Vibration at Idle in Drive

YEAR(S)	MODEL(S)	ADDITIONAL INFORMATION
2024 - 2026	GX550

Some 2024 – 2026 model year GX 550 vehicles may exhibit a vibration at idle when in drive. The Engine Control Module (ECM) logic has been modified, in addition to improved exhaust hangers, to help improve this condition. Follow the Repair Procedure in the bulletin to address this condition.

Figure 1.

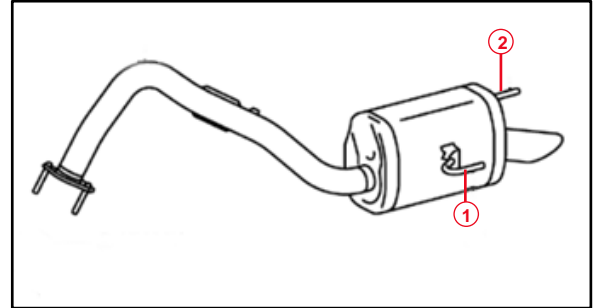
- Replace the exhaust supports on exhaust hangers three and four found in Figure 1.

1	Hanger 3
2	Hanger 4

Figure 2. Exhaust Support Hanger 3

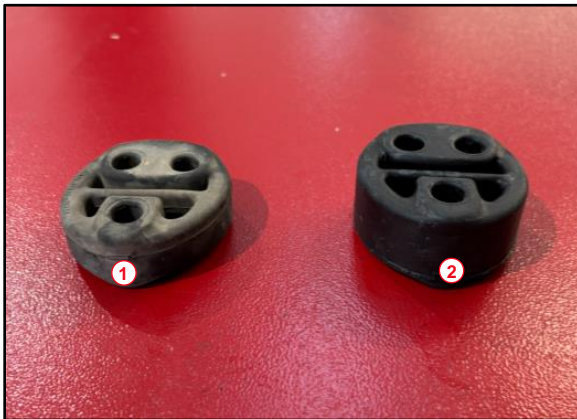
1	Original Exhaust Pipe Support (17565-74320)
2	Countermeasure Exhaust Pipe Support (17565-64180)

Figure 4. Rear Mount

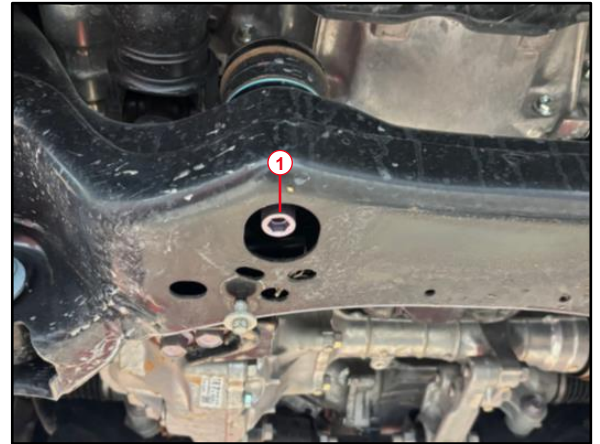
5. Loosen the front differential support points, as shown in Figure 4, Figure 5, and Figure 6.

7. Re-torque differential support bolts using proper torque specifications found in Repair Manual.
 - [2024 – 2026](#) GX 550:
Drivetrain – Axle and Differential – Front Differential Carrier Assembly – Installation
